BELL BEND NUCLEAR POWER PLANT
RESPONSE TO RAI No. 37 AND
SCHEDULE INFORMATION
BNP-2009-244 Docket No. 52-039

References: 1) M. Canova (NRC) to R. Sgarro (PPL Bell Bend, LLC), Bell Bend COLA – Request for Information No. 37 (RAI No. 37) – SEB1 -2659, 2660, 2661, e-mail dated July 27, 2009

Response to NRC Request for Additional Information No. 37
Bell Bend Nuclear Power Plant

FIGURE 1-19

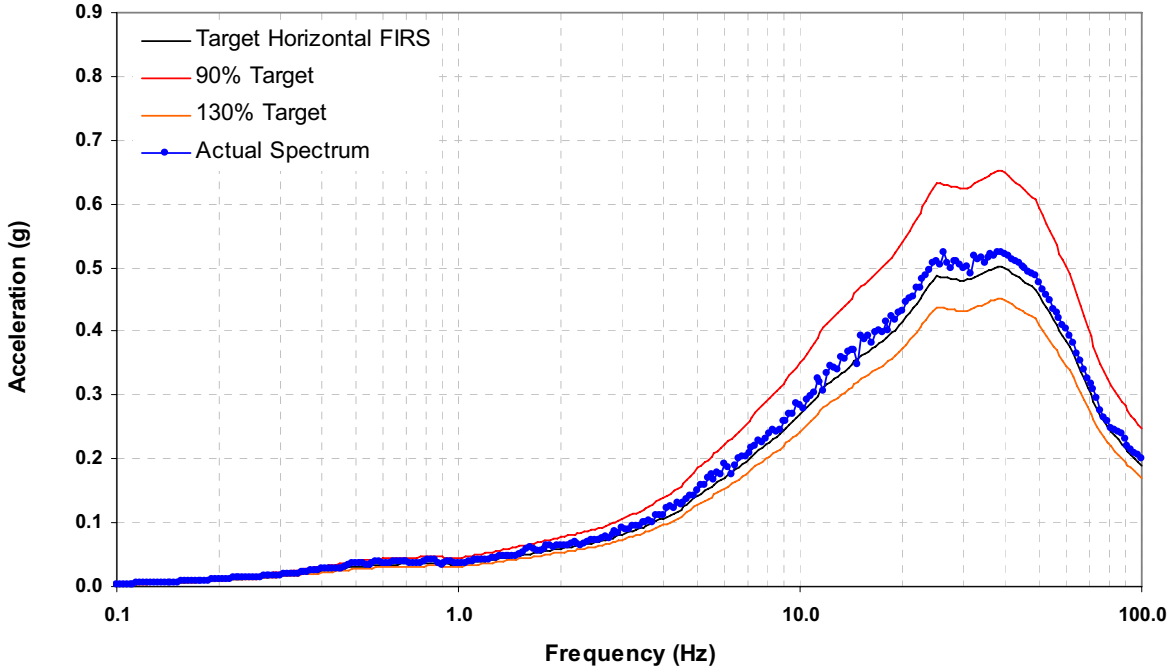
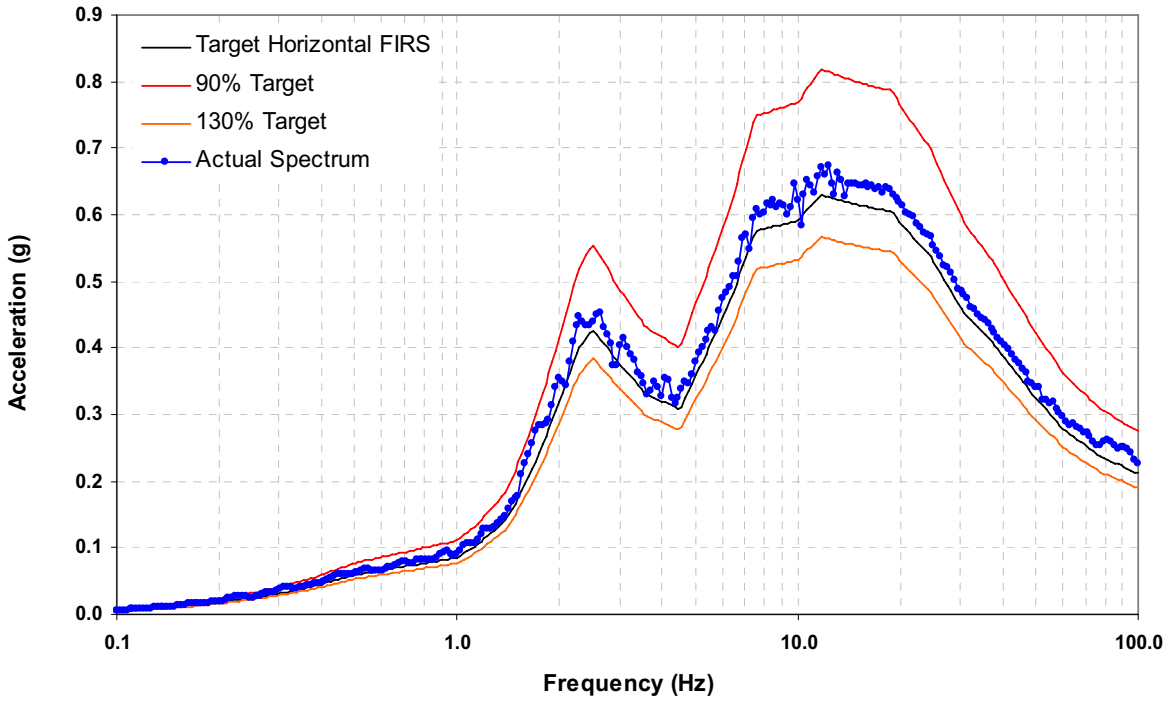
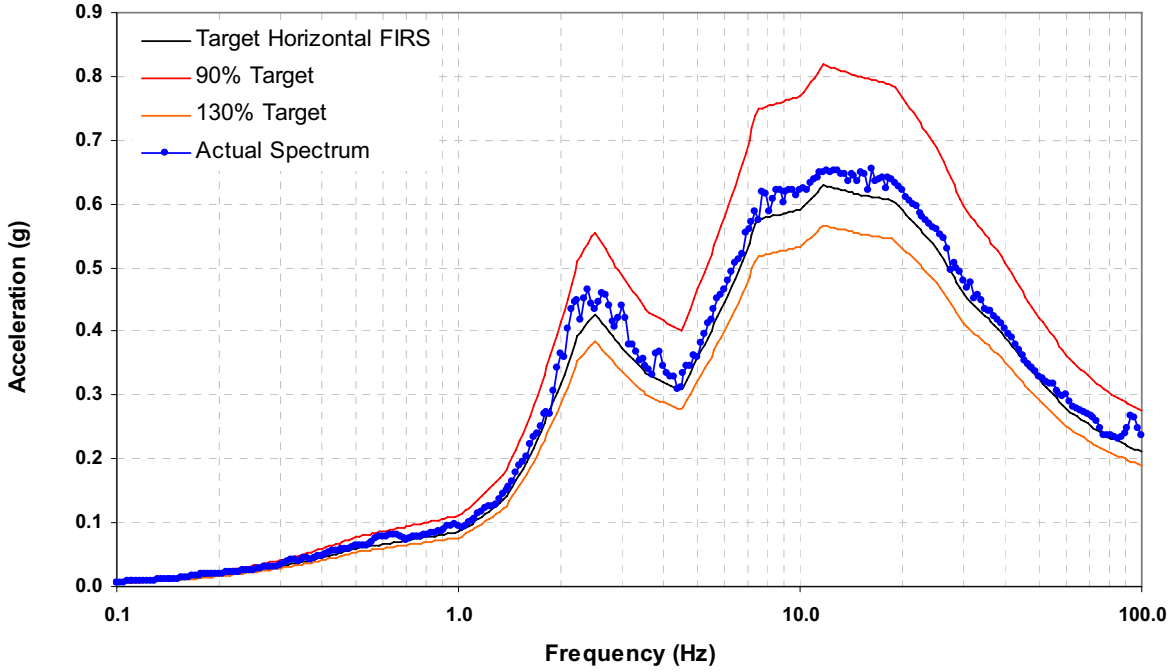
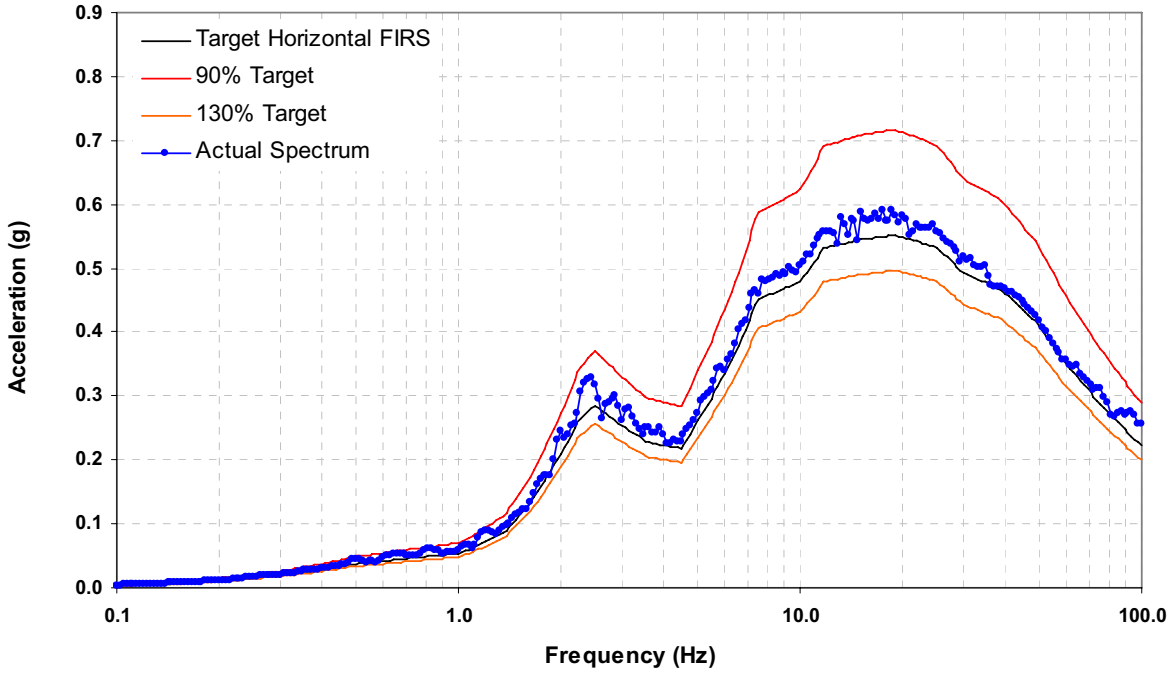
3) Describe the ground motion input time histories that were used in the SSI analysis and how they meet SRP Acceptance Criteria 1.B of SRP Section 3.7.1. In addition, provide a comparison of the response spectra of the input time histories to the FIRS for each of the structures and demonstrate how the response spectra of the input time histories meet Approach 1 or Approach 2 of SRP Acceptance Criteria 1.B of SRP Section 3.7.1.

Response
Figures 1-8 through 1-22 show the comparison of the 5% damped response spectrum of the input time histories, and 90%, 100% and 130% of the target response spectra for five structures (3URB, 4URB, 12URB, 12UBP, 34UBP). The comparison demonstrates that the 5% damped response spectra of the time histories do not fall more than 10% below the target response spectra, and do not exceed the target response spectra by more than 30%.

FIGURE 1-1
HORIZONTAL GMRS AND FIRS COMPARISON

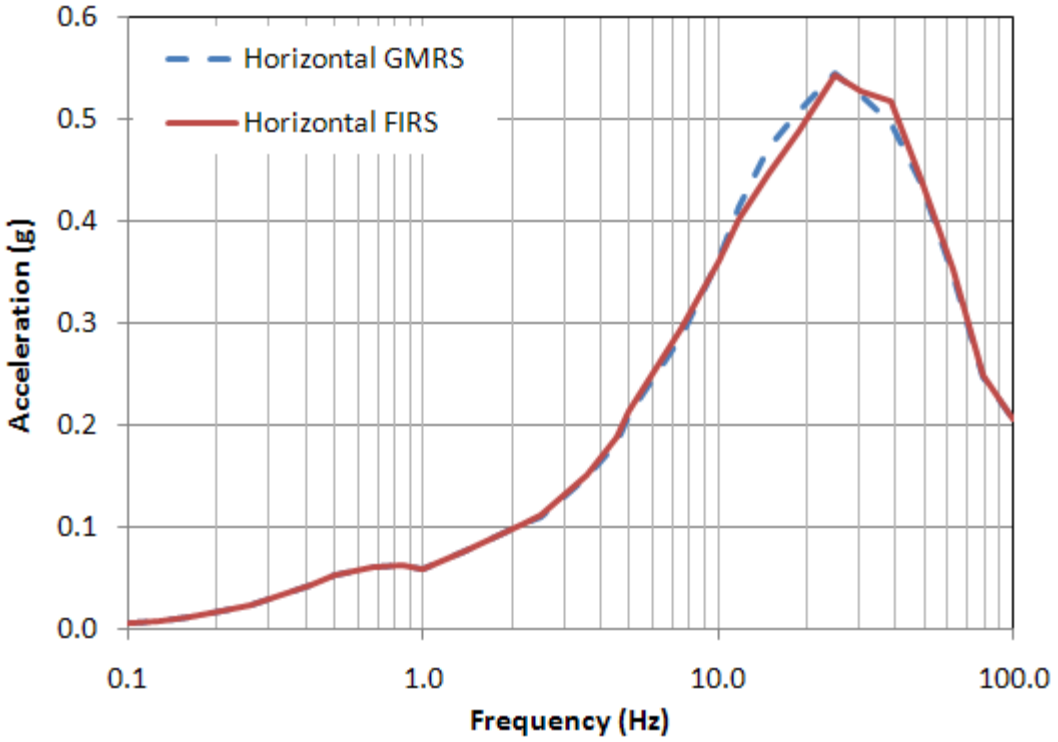
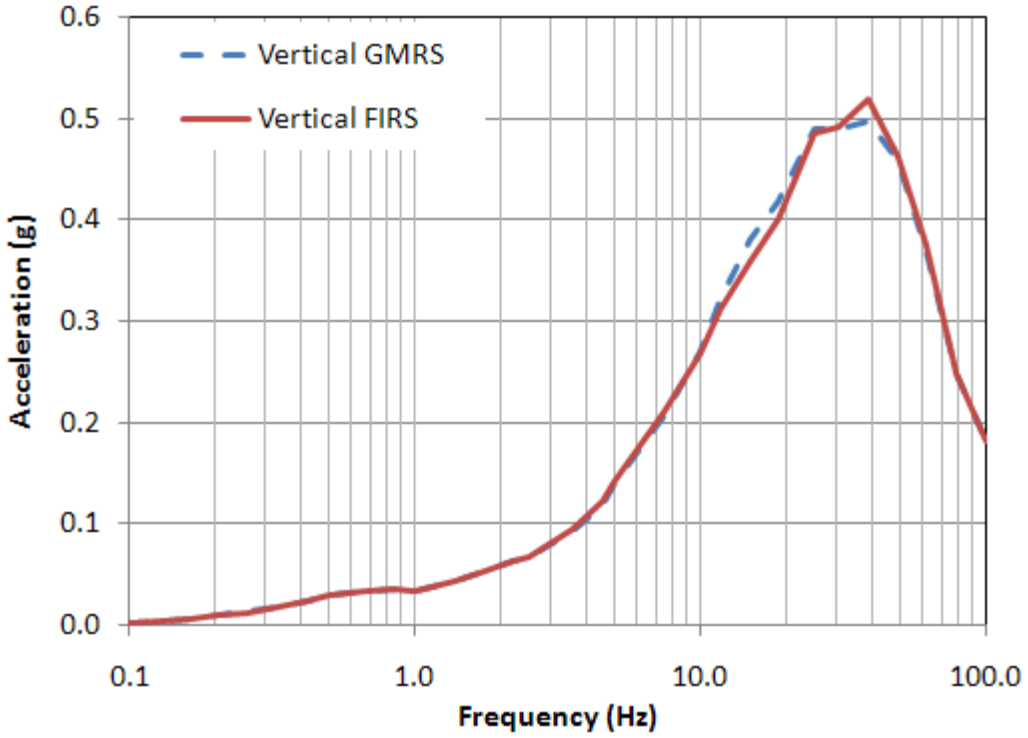
1) In Figure 3.7-131, it is not clear that the FIRS shown envelope the GMRS at all frequencies. Accordingly, provide a comparison of the GMRS with the FIRS for both the horizontal and vertical directions. In addition, provide the specific steps that are used, including the computer codes, to develop the FIRS for this structure.

Figures 1-1 and 1-2 provide the comparison between GMRS and FIRS. Although both curves are very similar, the GMRS does not envelope the FIRS. The statement that the "GMRS envelopes the FIRS" has been removed from the FSAR and that change was reflected in Revision 1 of the COLA. FSAR Figures 2.5-138 and 2.5-139 provide the soil profile used for the development of the ESWEMS Pumphouse FIRS. Response to Question 03.07.01-4 provides a description of the theoretical basis for the development of the FIRS. For the particular case of the ESWEMS pumphouse, the FIRS were developed at zero depth without considering embedment and with a surface outcropping motion. Section 2.5.2.6 of the FSAR describes the process for development of vertical spectra by scaling the horizontal spectra by a frequency-dependent vertical-to-horizontal (V/H) factor.

Figure 3.7-131 {Horizontal and Vertical Firs at Elevation 669 ft msl (203.9 m)}

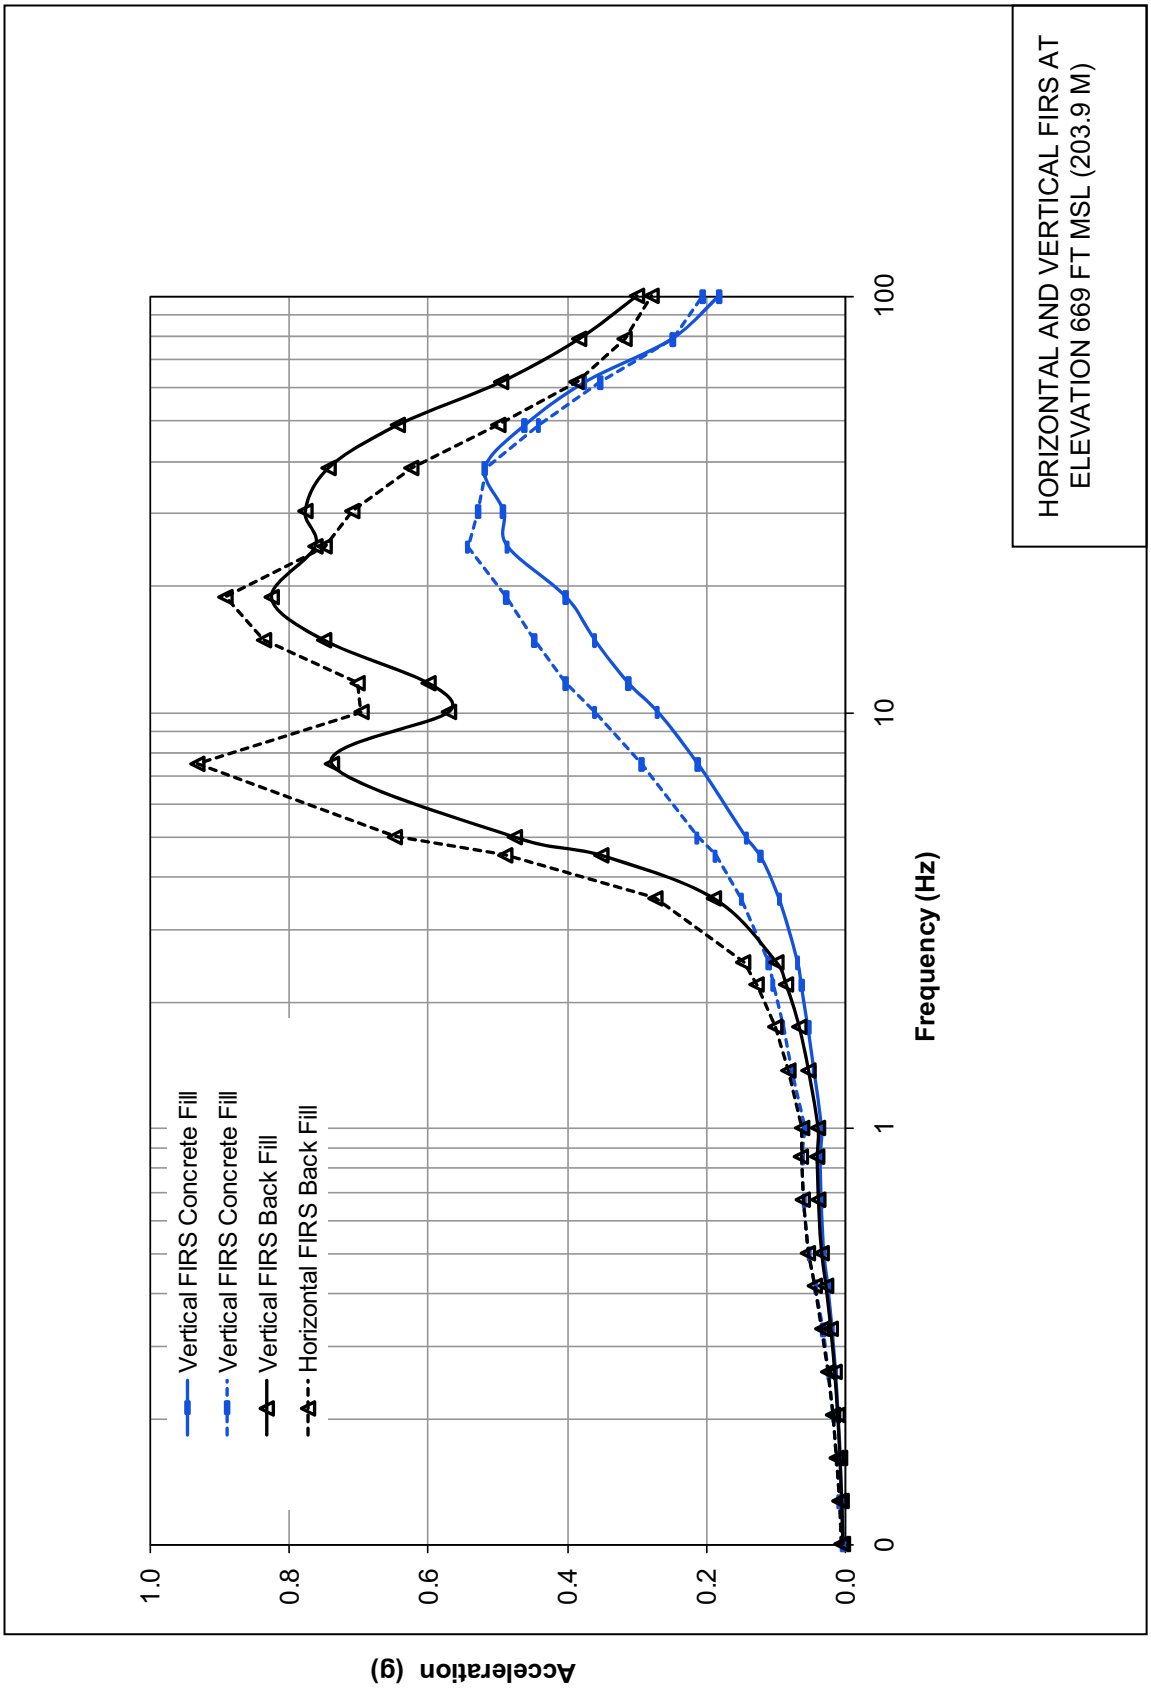
3) FSAR Section 3.7.2.1.2 (Response Spectrum Method) states on page 3-41 that Figure 3.7-1 presents the response spectrum at 5 percent damping used in the analysis of the ESWEMS. The referenced figure is actually the GMRS. Is this the correct reference? If not, provide the correct reference in the FSAR.

Response
FSAR Section 3.7.2.1.2 inadvertently lists Figure 3.7-1 as presenting the response spectrum at 5 percent damping used in the Response Spectrum analysis of the ESWEMS. The referenced figure should have been Figure 3.7-131 (Concrete Back Fill) as the input FIRS. It is noted that actual analysis has used engineered back fill rather than concrete back fill (Figure 3.7-131) as the input FIRS. The comparison of the input FIRS (FIRS Back Fill) with FSAR Figure 3.7-131 (FIRS Concrete Fill) is included in Figures 3.7-131 It can be seen that the input FIRS (Back Fill) for the design of the ESWEMS Pumphouse enveloped the required FIRS (Concrete Fill) by a wide margin for frequencies beyond 1.0 Hz.. Therefore, the design is conservative. As a result, subject FSAR Section and Figure 3.7-131 will be revised.

.FSAR Figure 3.7-131 will be replaced with the following:
